**BAKERSFIELD CITY SCHOOL DISTRICT
ROOSEVELT ELEMENTARY SCHOOL MODERNIZATION
BAKERSFIELD, KERN COUNTY, CALIFORNIA**

Job No. 1317
Appl. No. 15-6
File No. 03-122920

ADDENDUM NO. #02

NOTICE TO CONTRACTORS FIGURING THIS WORK

PARTIAL SITE PLAN

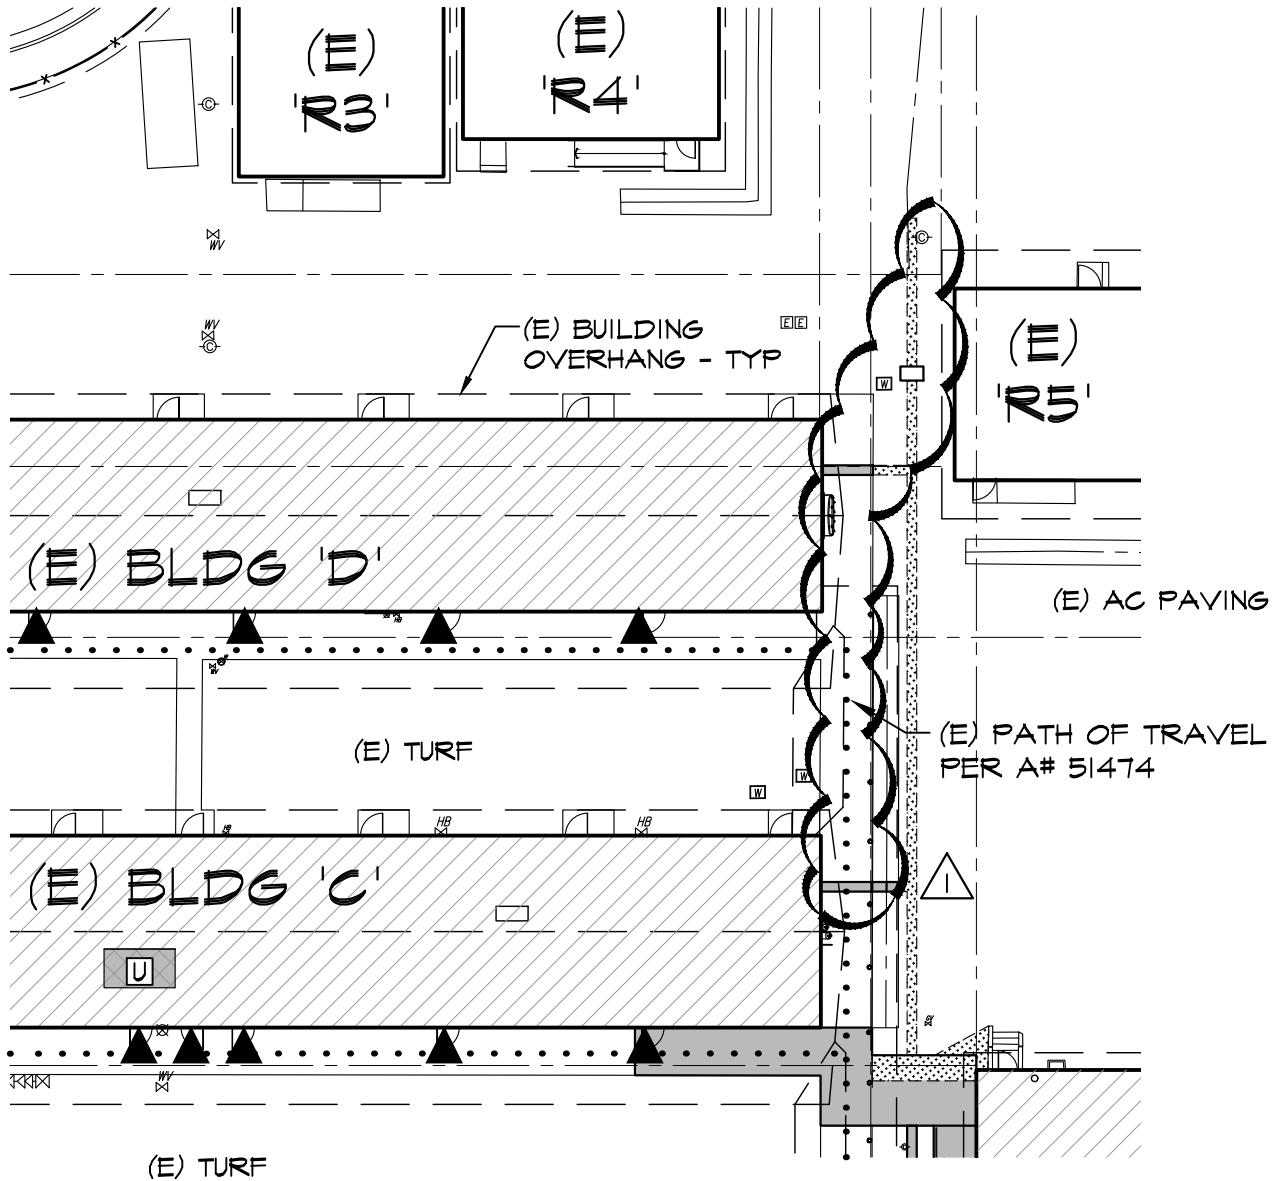
- a. REVISE: Trenching on East side of Buildings C & D for conduit run from Panel “PC” to Panel “PD” to be as per attached Drawing Nos. 01 and 02.
 - b. ADD: Note – District will cap any irrigation as required, Contractor to repair any irrigation lines damaged by Contractor during course of construction by their personnel.

△ REVISING TRENCH FOR
ELECTRICAL CONDUIT

PARTIAL DEMO FLOOR PLAN

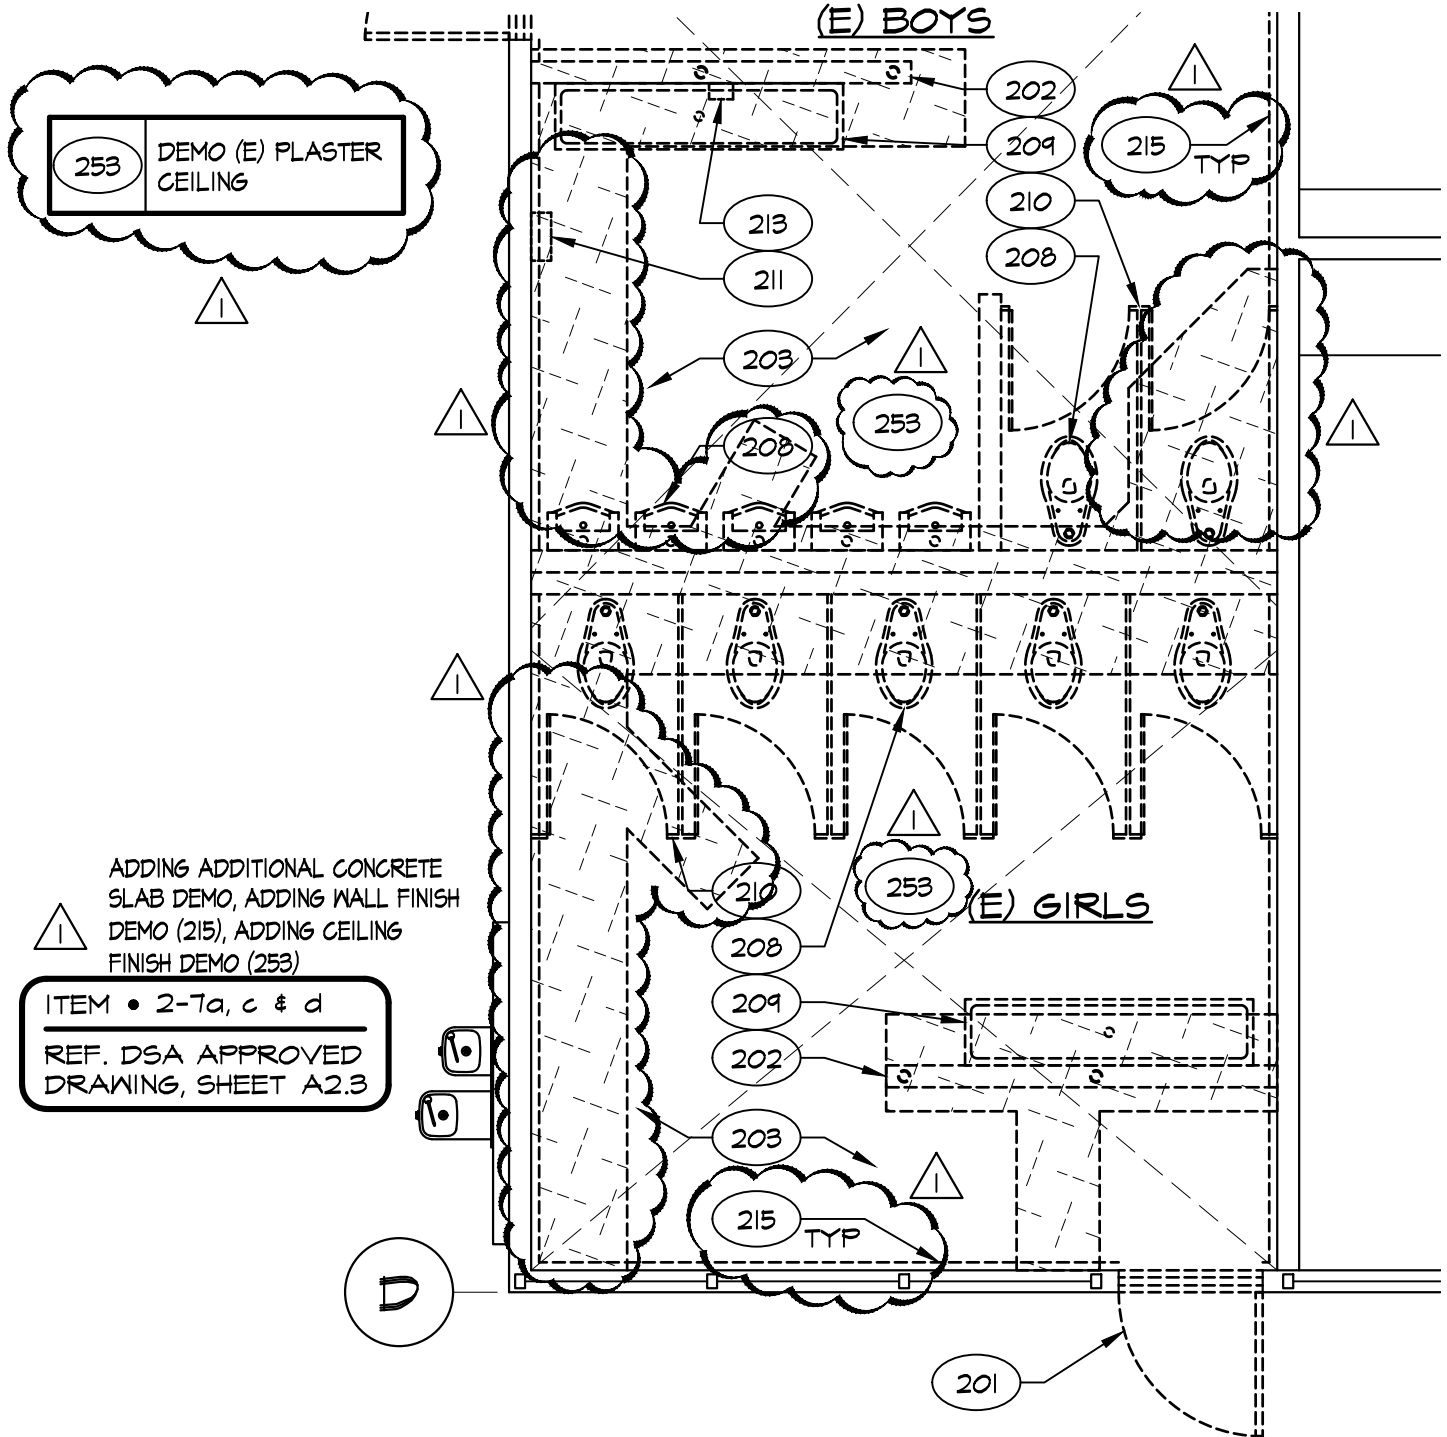
- 2-7) Refer to DSA Approved Drawings, Sheet No. A2.3 FLOOR PLAN BUILDING “D”, PARTIAL FLOOR PLAN & DEMO PLAN, ROOMS 401 BOYS & 402 GIRLS;
- a. REVISE: Concrete slab demo and replacement as indicated per attached Drawing Nos. 03 and 04.

- b. ADD: Keynote (215) to the interior perimeter of each room as indicated per attached Drawing No. 03.
 - c. ADD: Keynote (253) DEMO (E) CEILING FINISH to Keynote Schedule and to each room as indicated per attached Drawing No. 03.

PARTIAL FLOOR PLAN

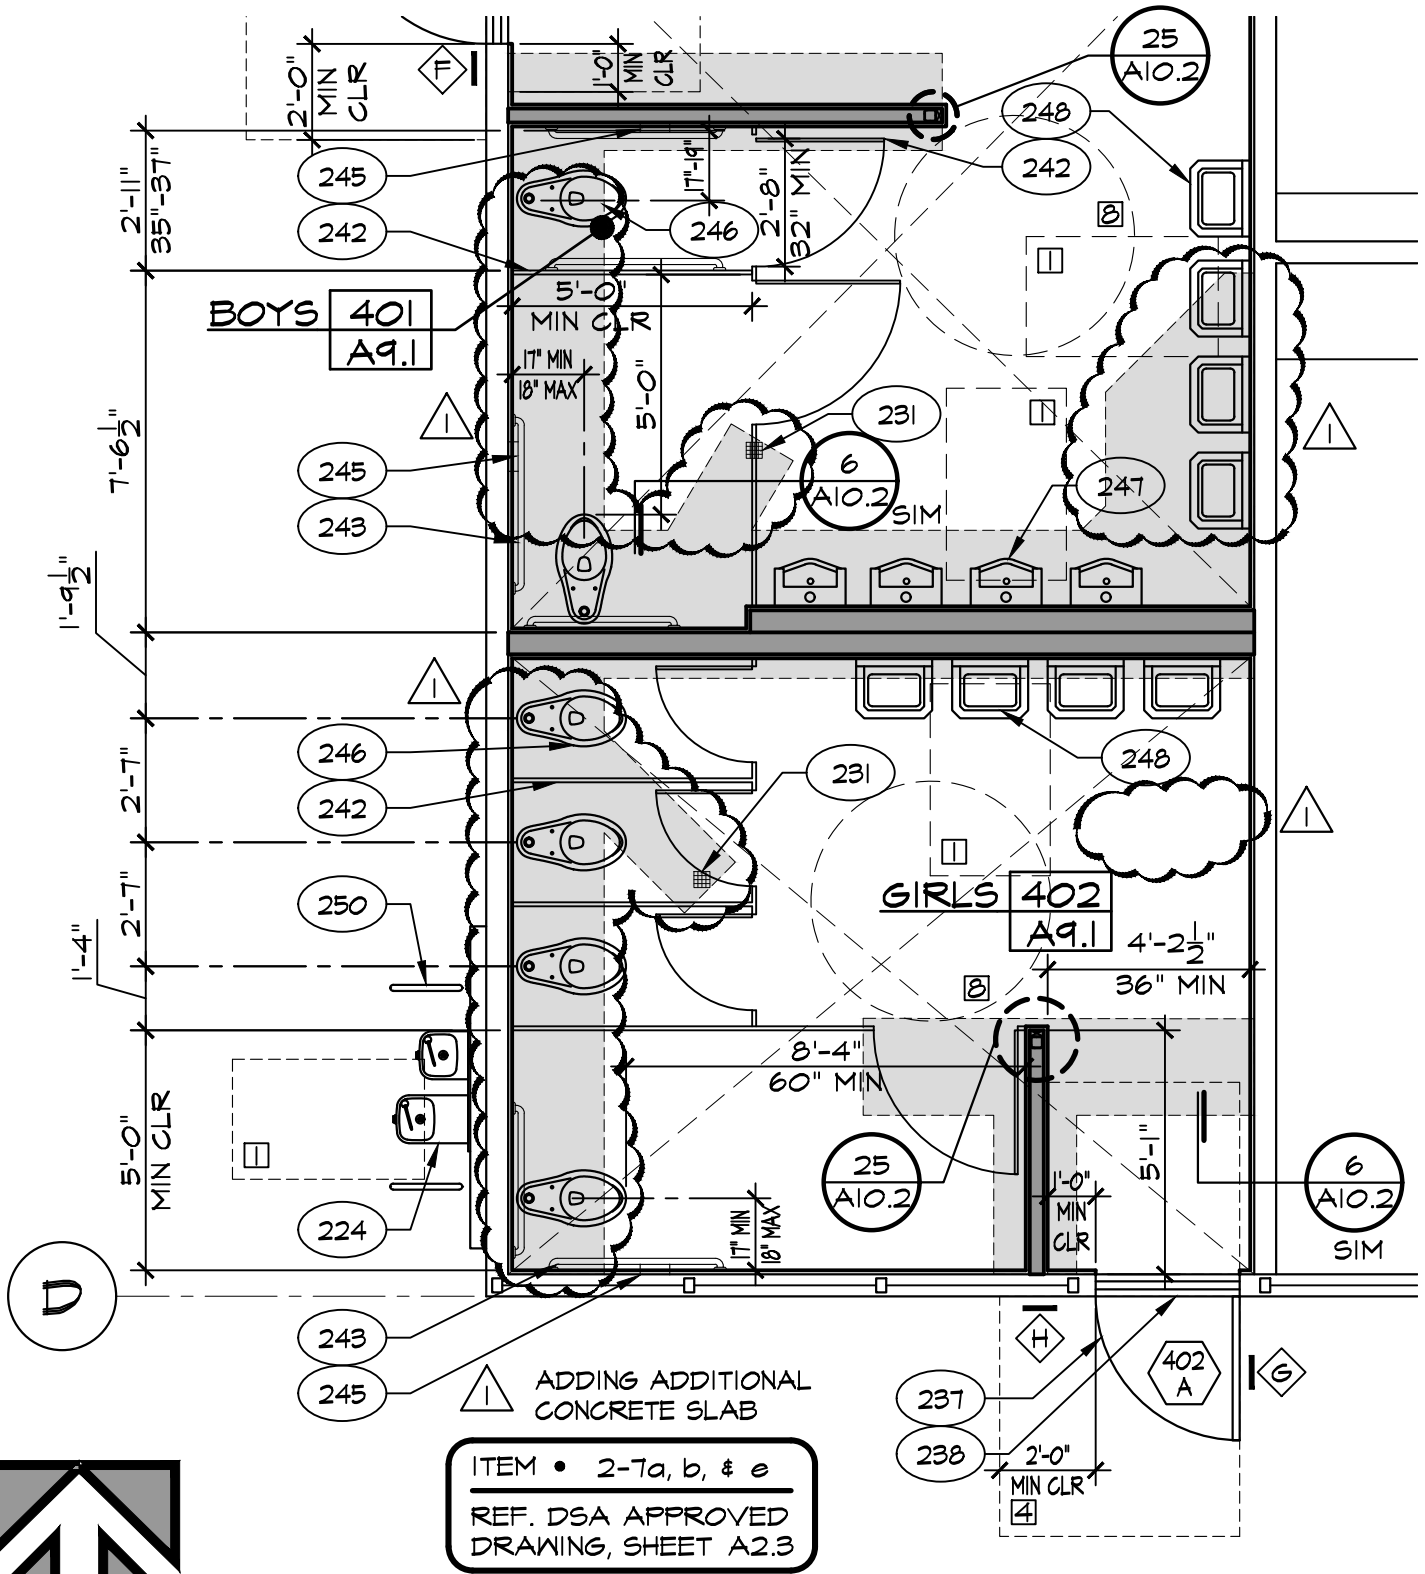
- d. DELETE: Keynote (245) from East wall of Room 402 as indicated per attached Drawing No 04.
- 2-8) Refer to DSA Approved Drawings, Sheet No. A2.4 FLOOR PLAN BUILDING “E” & DEMO FLOOR PLAN BUILDING “E”, (B) DEMO FLOOR PLAN BUILDING “E”, ROOMS (E) CLOSET, (E) STORAGE, (E) CLOSET;

△ ADDING DETAIL #2

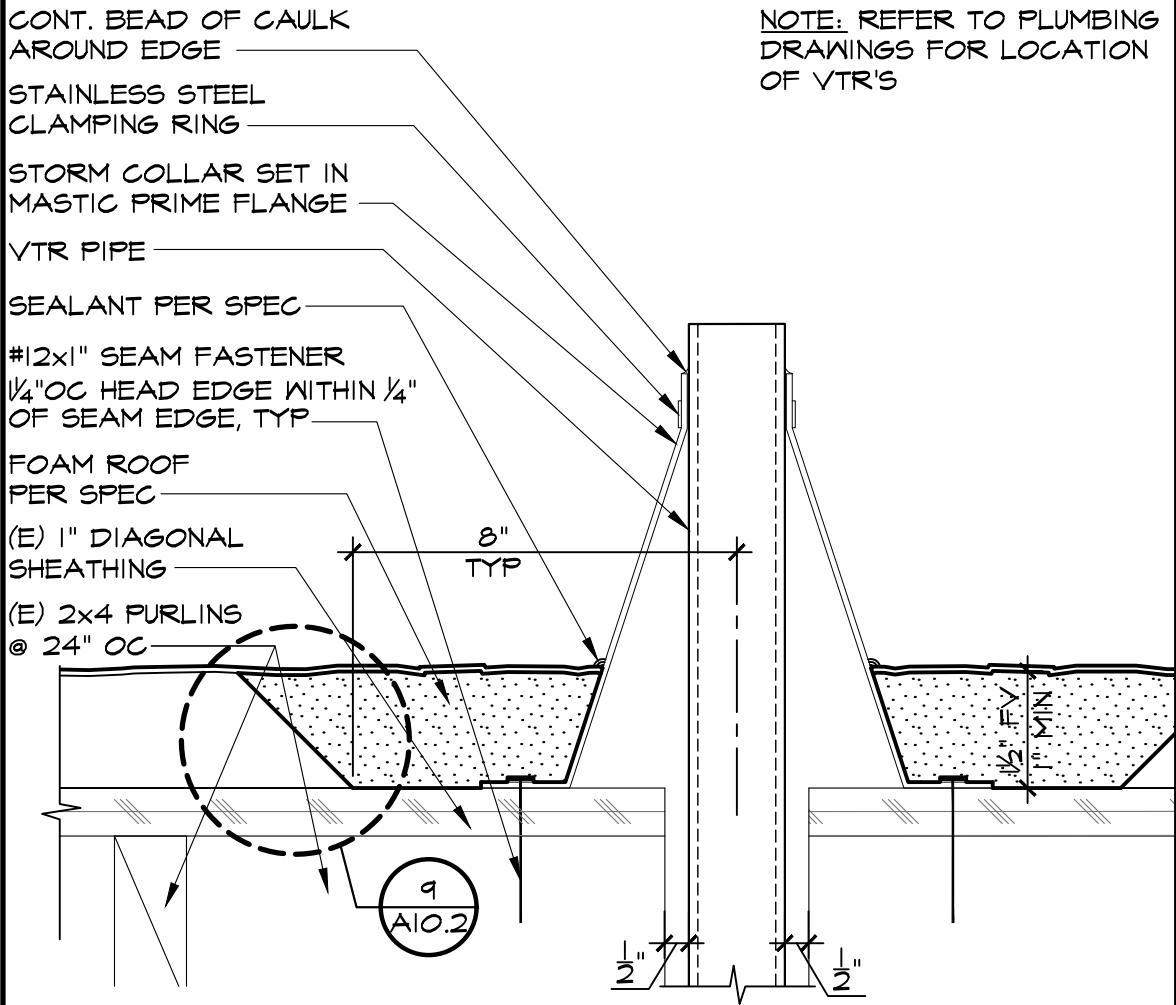
- 2-10) Refer to DSA Approved Drawings, Sheet No. A10.2 DETAILS;
- a. ADD: Detail #2 as indicated per attached Drawing No. 05.
- 2-11) Refer to DSA Approved Drawings, Sheet No. A9.0 INTERIOR ELEVATIONS, EAST ELEVATION OF ROOM 106 CORRIDOR;

REF. DSA APPROVED
DRAWING, SHEET A9.0

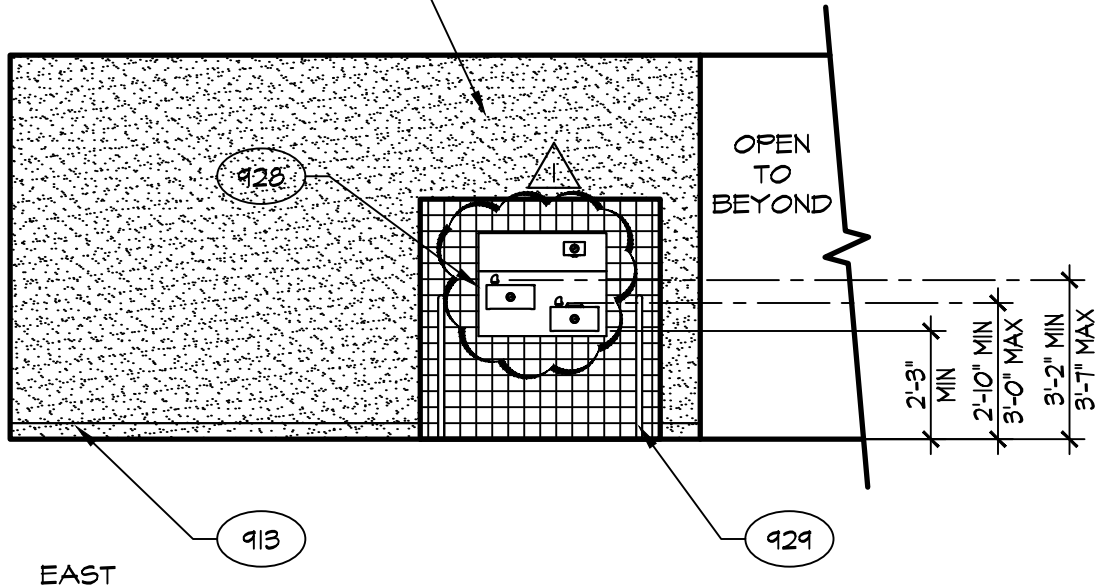
- a. REVISE: Graphic of drinking fountain to match scheduled fixture as indicated per attached Drawing No. 06.
- 2-12) Refer to DSA Approved Drawings, Sheet Nos. 6.0 PARTIAL ROOF PLAN BUILDINGS “B”, “C” & “D”, BUILDING “D” and A6.1 PARTIAL ROOF PLAN BUILDING “E”;

PARTIAL ROOF PLAN BUILDING 'D'

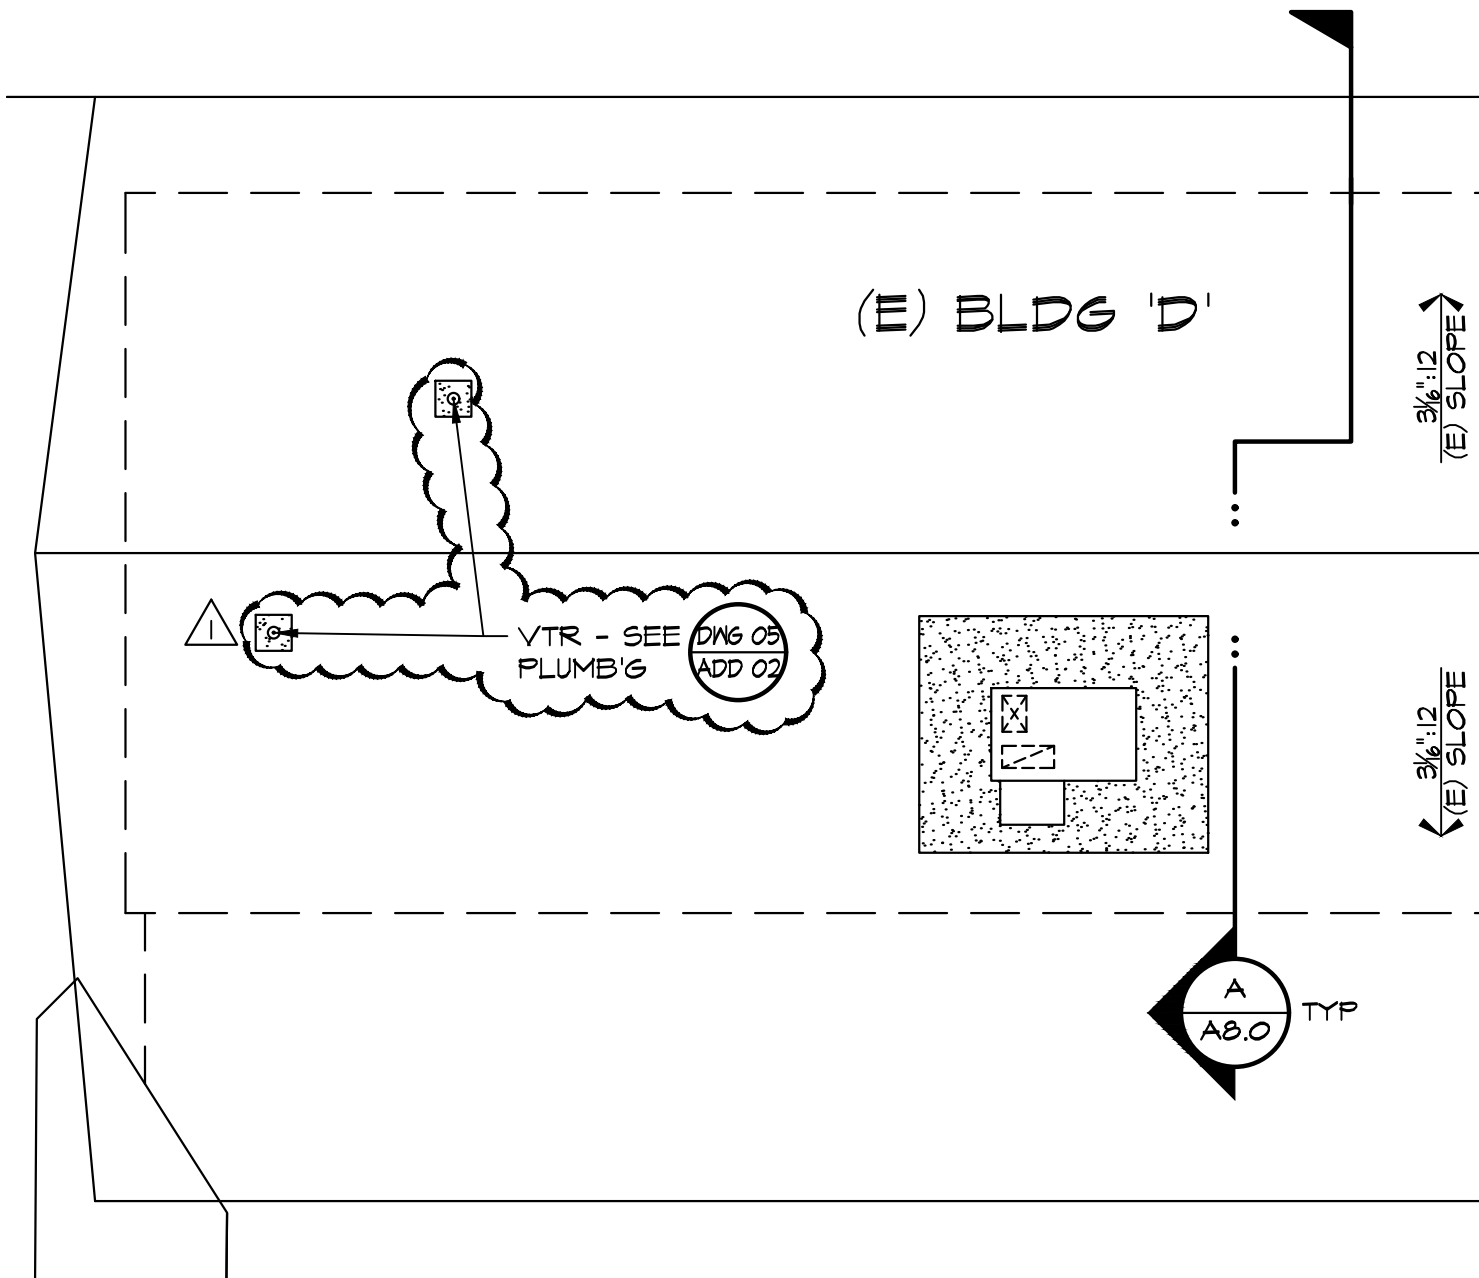
- a. ADD: VTR’s and roof patching as indicated per attached Drawing Nos. 07 & 08.

△ ADDING VTR'S
